UPDATE: HORIZON 29A, Schematic Change

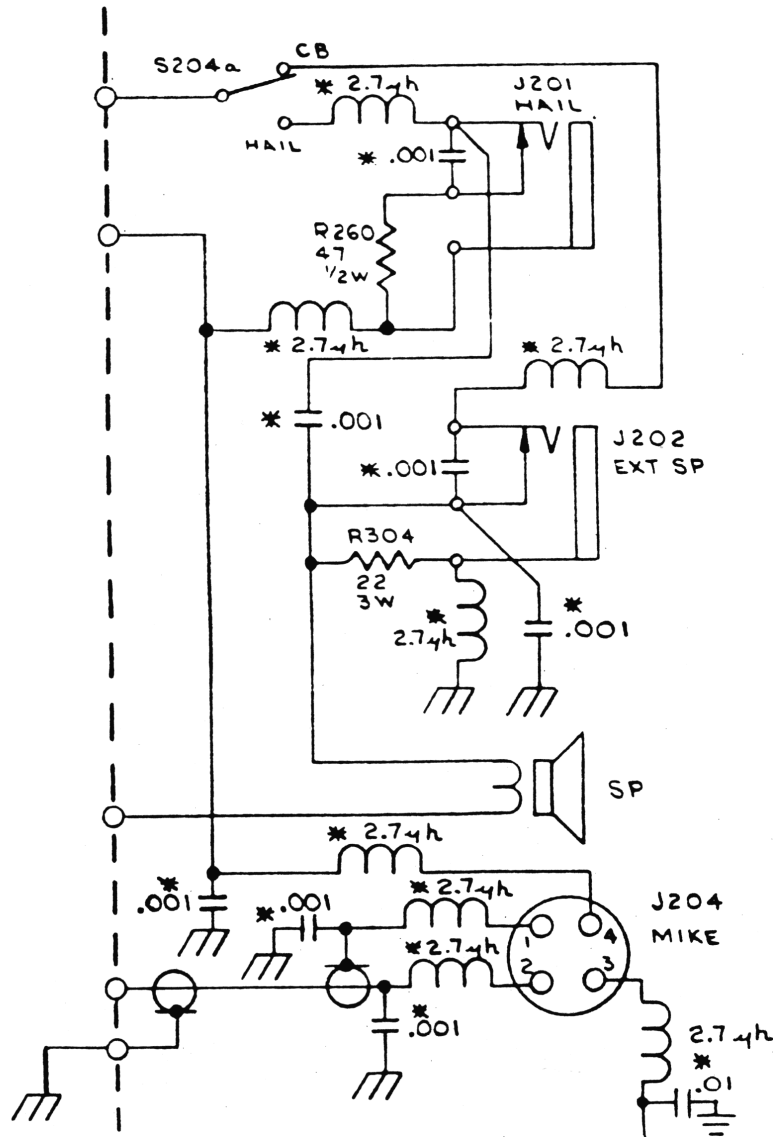
Above diagram shows revision to mike and speaker circuit for the Horizon 29A. Check against your original schematic or SAMS. Parts added are indicated with an asterisk (*).
